2015SYE158 – 34-38 Railway Crescent, Jannali

DA15/1345

ASSESSMENT REPORT APPENDICES

DEFERRED COMMENCEMENT CONSENT

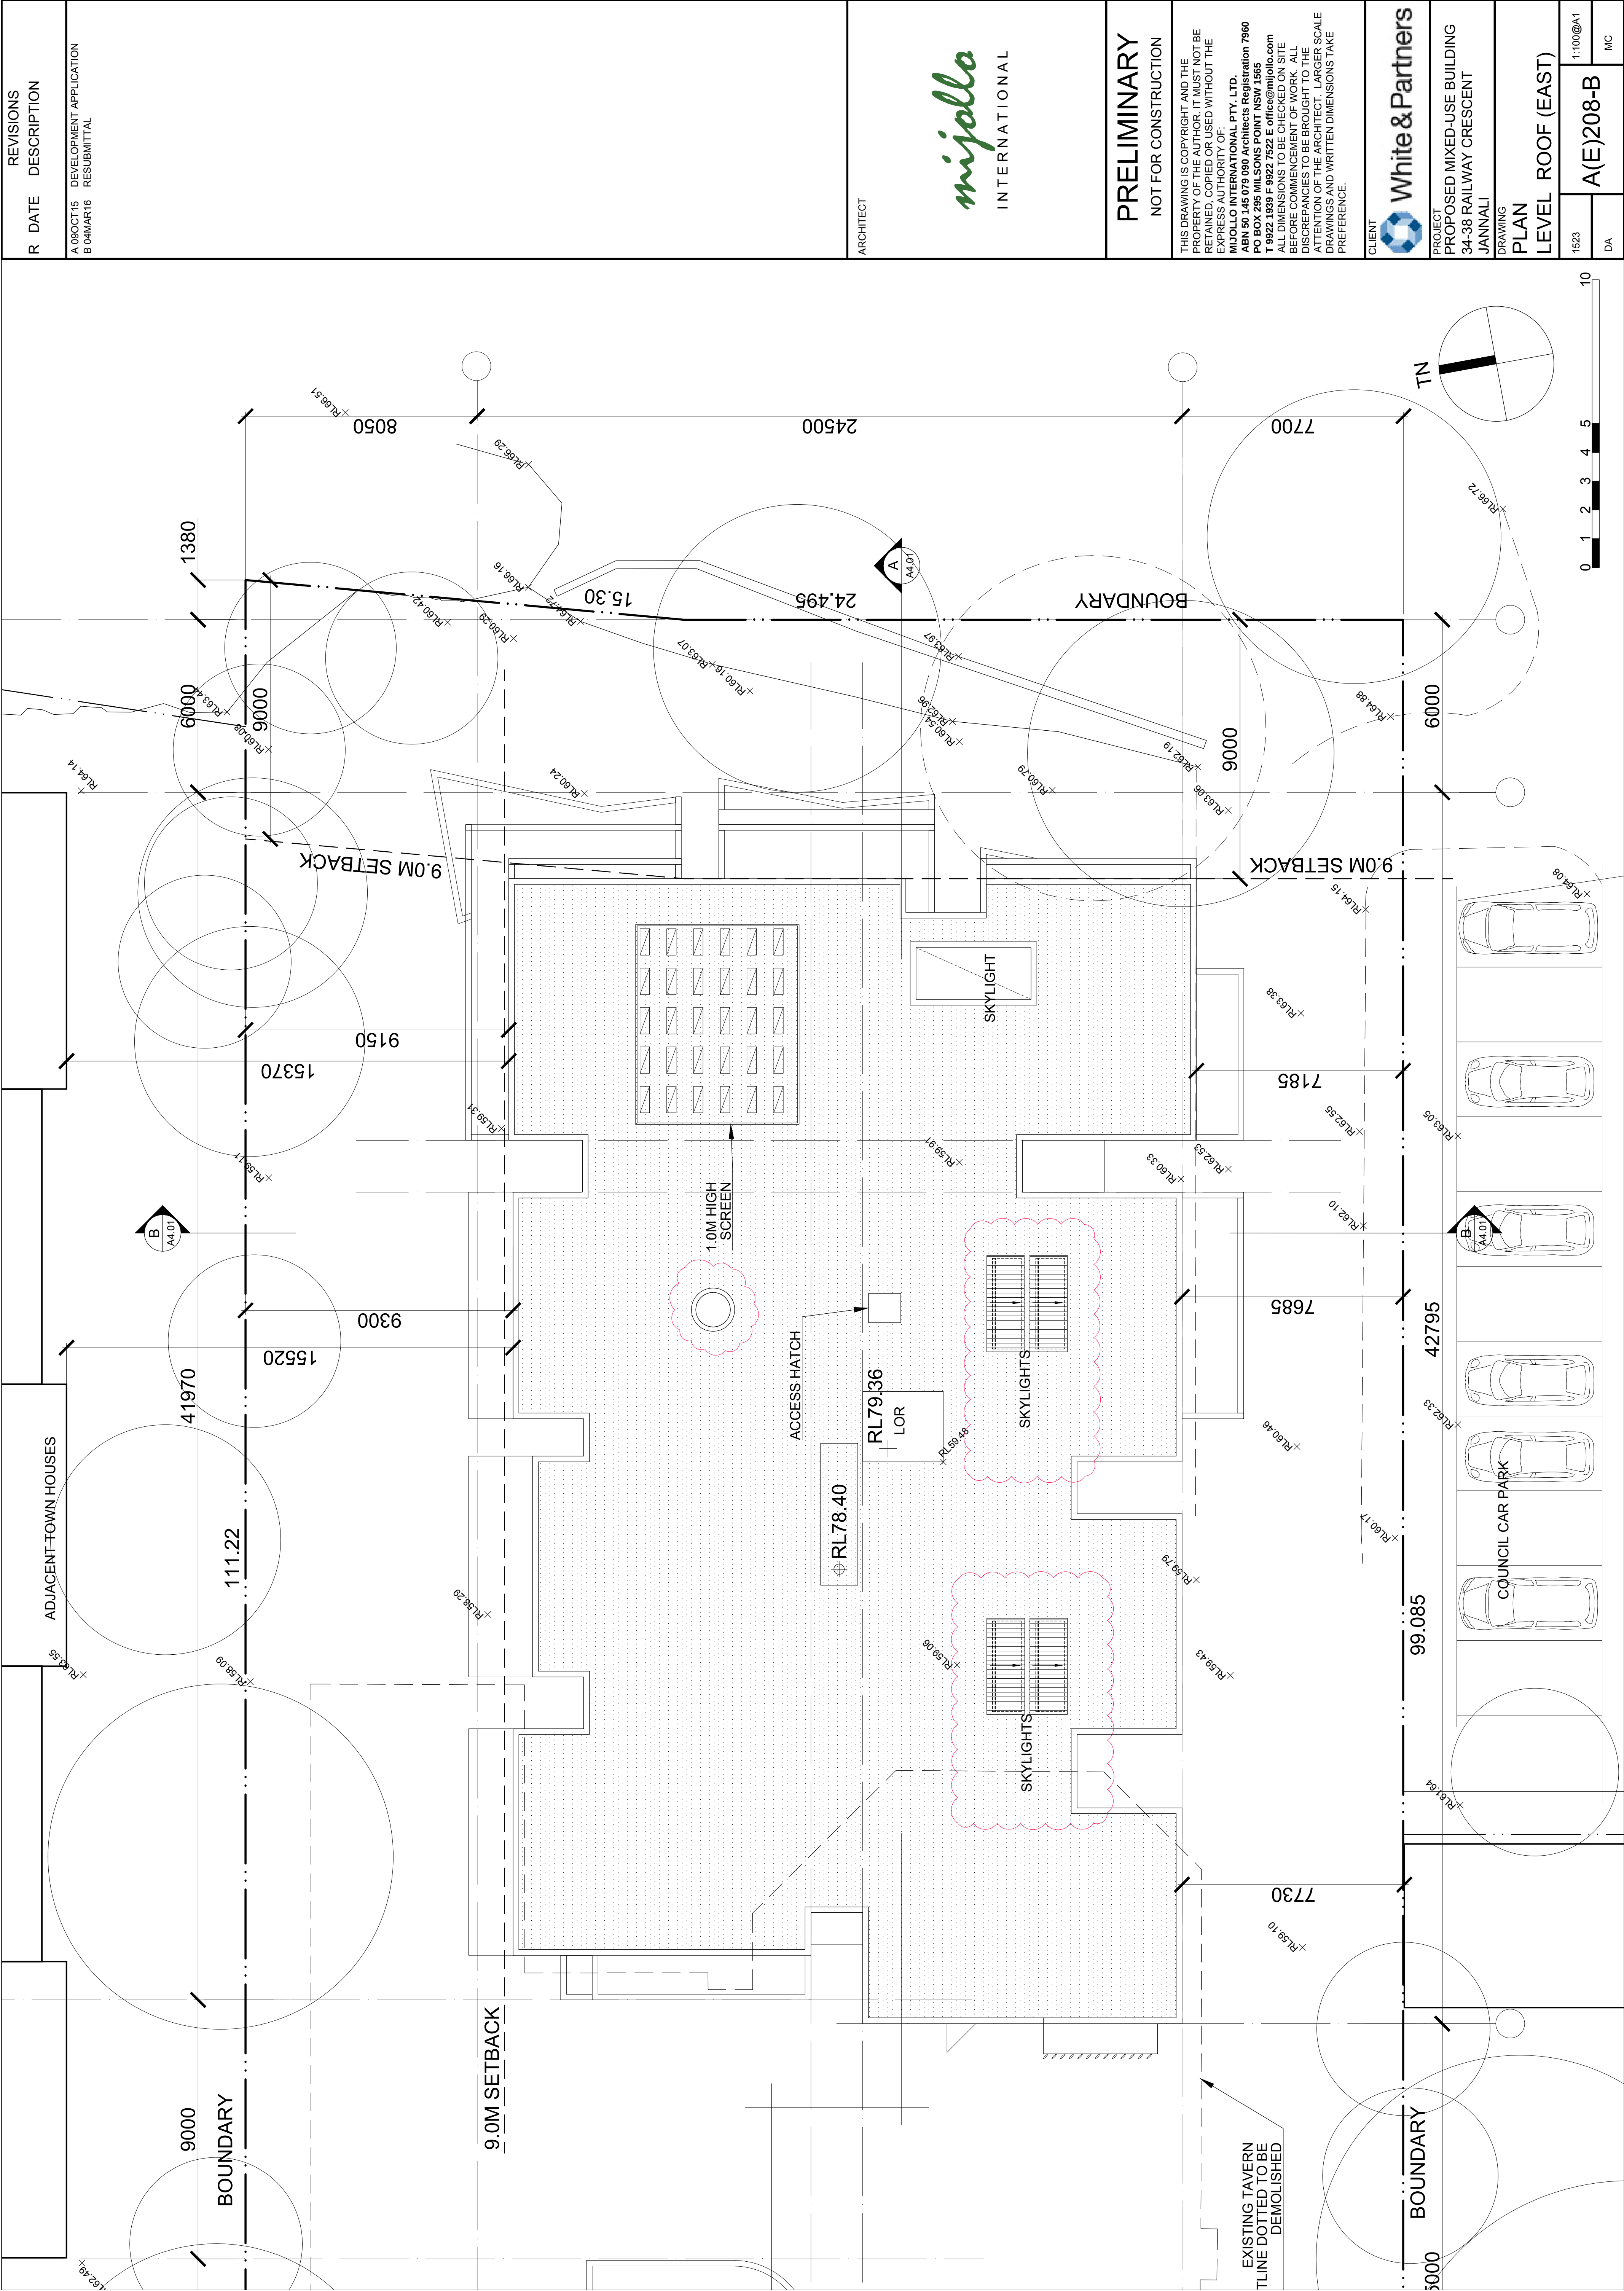
While there is reasonable cross-ventilation and daylight access to the majority of the apartments, compliance with solar access and cross ventilation requirements of the ADG is mandatory. The ventilating skylight to Unit 7.04 is missing from the roof plan A(E)208-A.
